**CONFERENCE CALL AGENDA
BEACON SOLAR ENERGY PROJECT
(08-AFC-02)
WEDNESDAY, MAY 21, 2008 (10:00 a.m. to 12:00 p.m.)**

**CONFERENCE CALL MEETING NOTES
BEACON SOLAR ENERGY PROJECT
(08-AFC-02)**

Resolve issues raised by California Department of Fish and Game (CDFG) regarding additional information needs for completing Incidental Take Permit (ITP) application for desert tortoise (DT) and Mohave ground squirrel (MGS).

Figure 6
Vegetation Communities

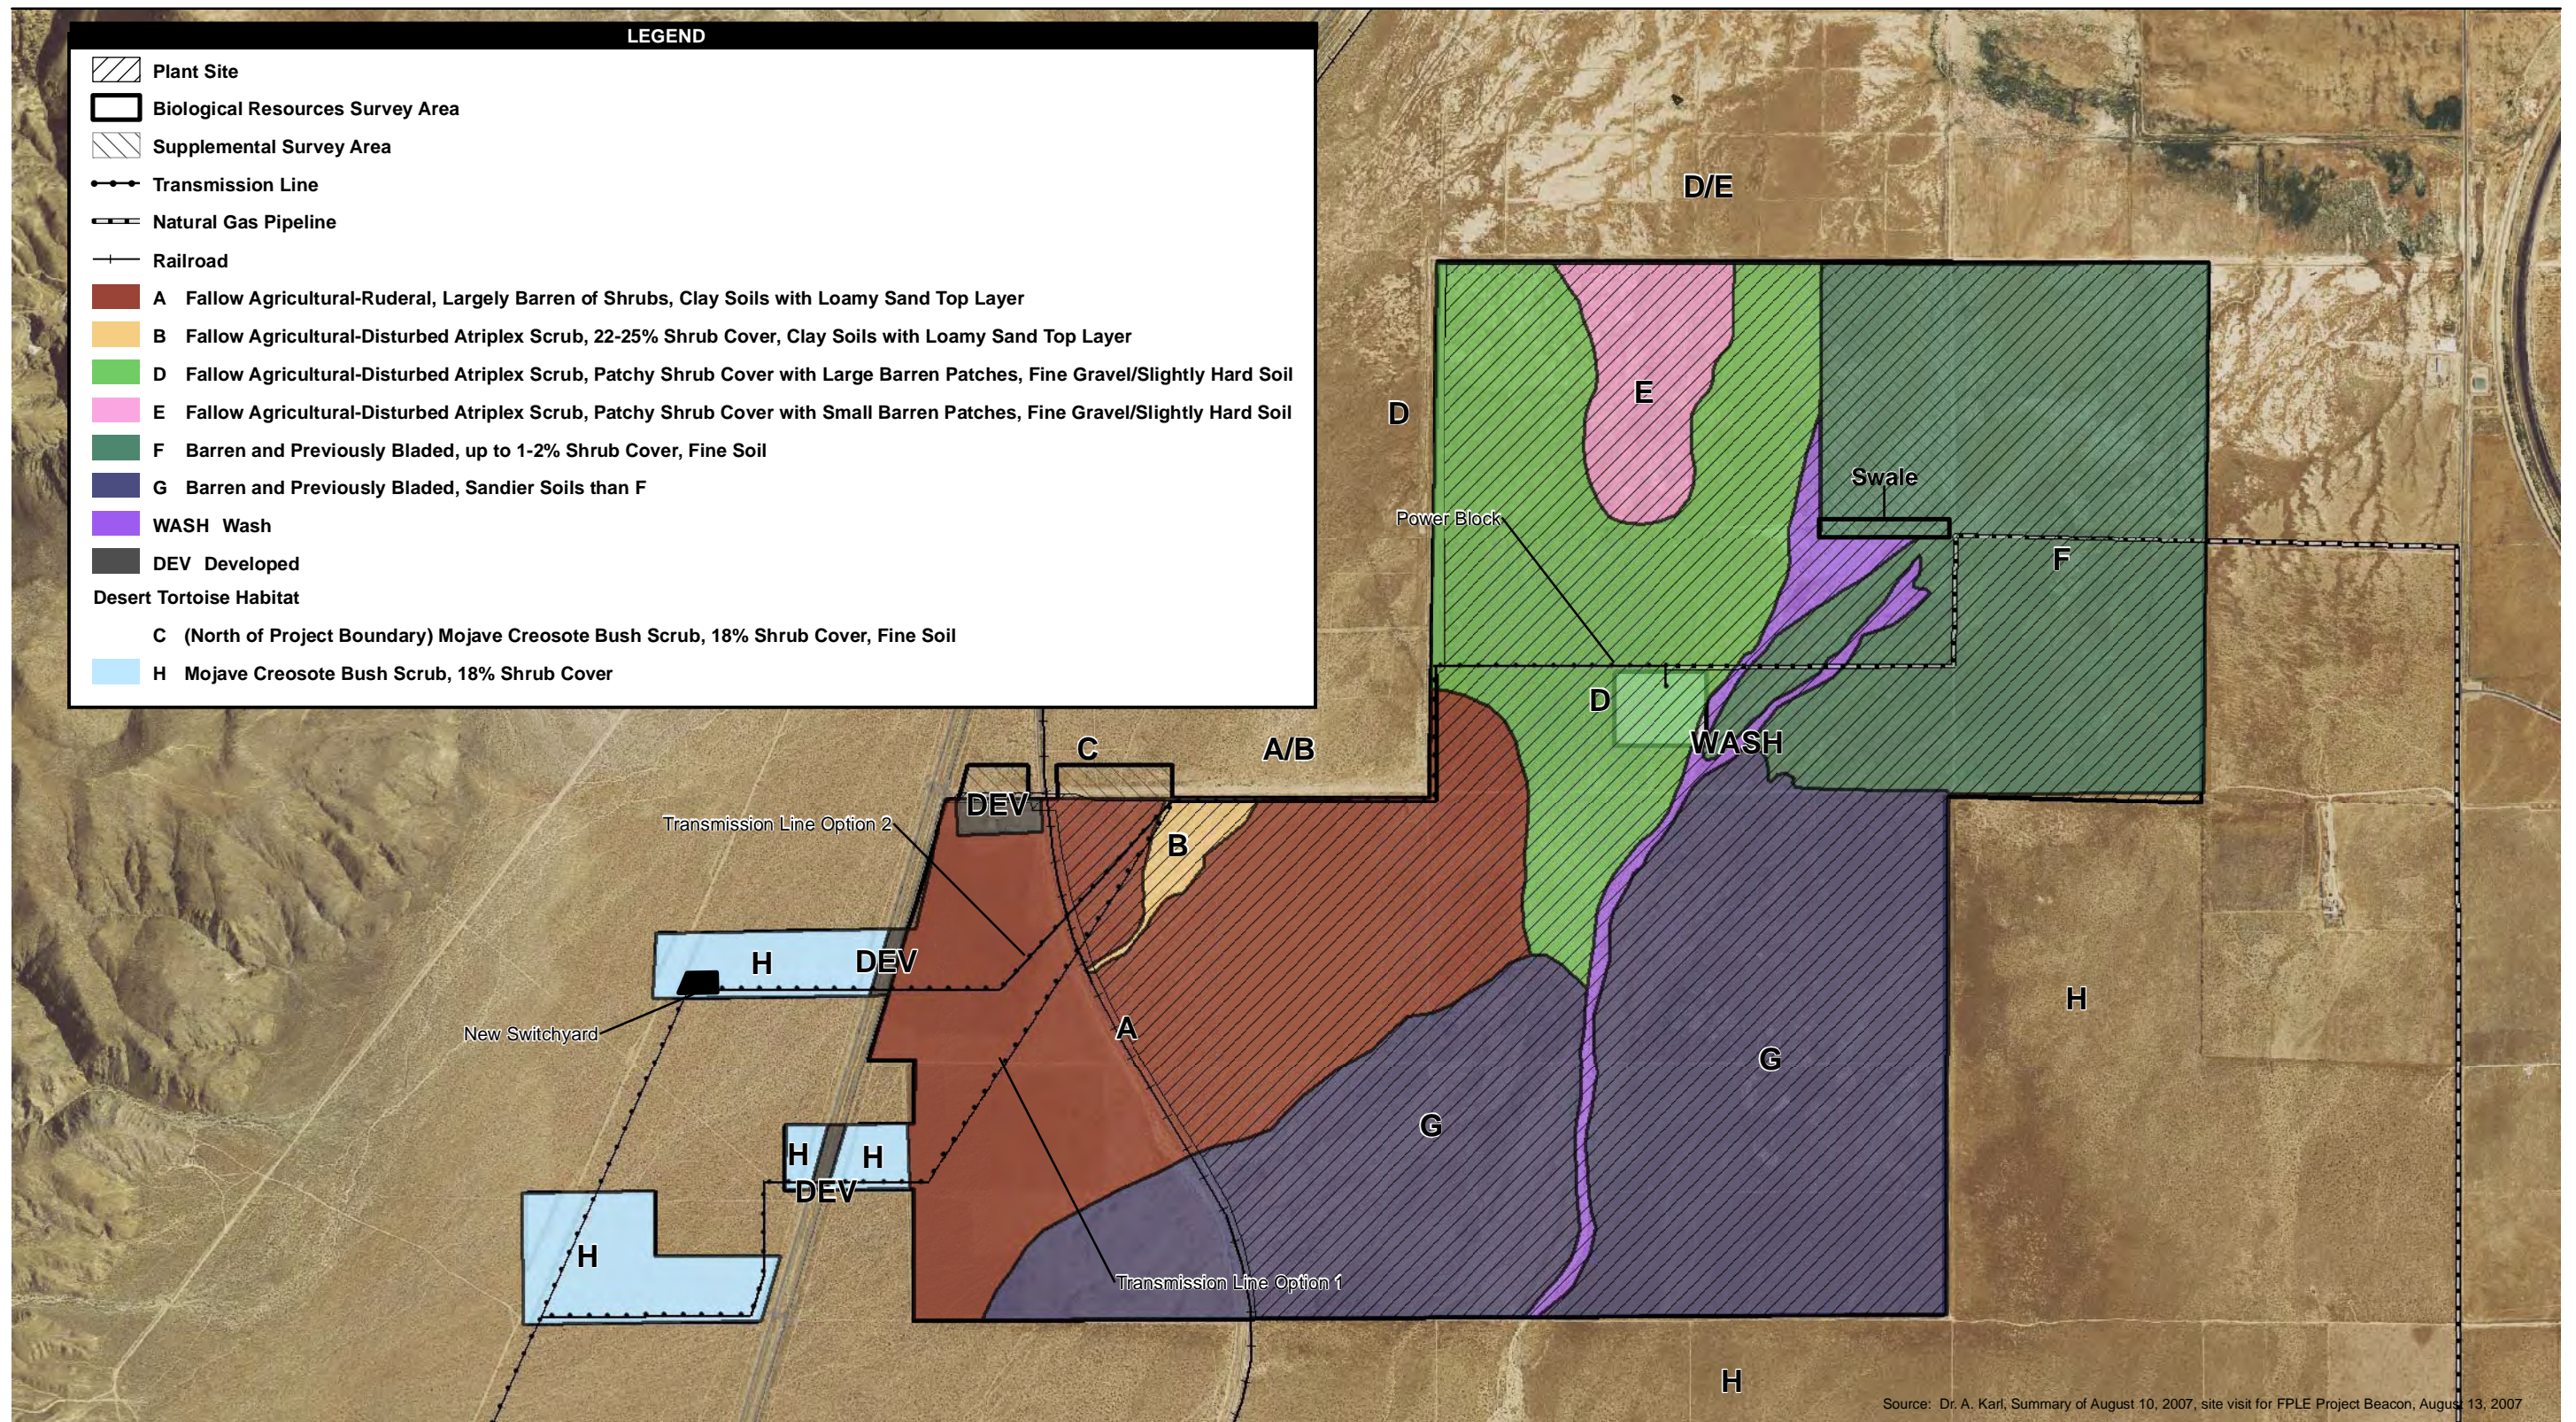
Kenny directed everyone's attention to Figure 6 in the handout, which provided as precise a depiction as possible of vegetative cover. He also pointed out that there were a few minor corrections to be made in the acreage totals for the habitat types, and those are included in the sheet labeled "New Table" in the handout that was sent out. This new table has permanent and temporary impacts for different habitat types.

Kim asked if the project requested take coverage for, hypothetically, two dispersing individual MGS, what type of mitigation would be appropriate? Julie responded that we need to know how close suitable habitat is located, and whether take coverage is being sought solely for construction or also for ongoing operations for 30 years of potential take. Kenny indicated that Beacon Solar will make this clear in the revised application. Phil spoke to the dispersal issue. Based on his research on behavior of dispersing MGS in radio-transmitter work with juveniles, he found they came to a playa and stopped. They won't cross large open areas. Looking at Figure 6, there just isn't much habitat to disperse from that isn't separated by wide swaths of barren terrain.
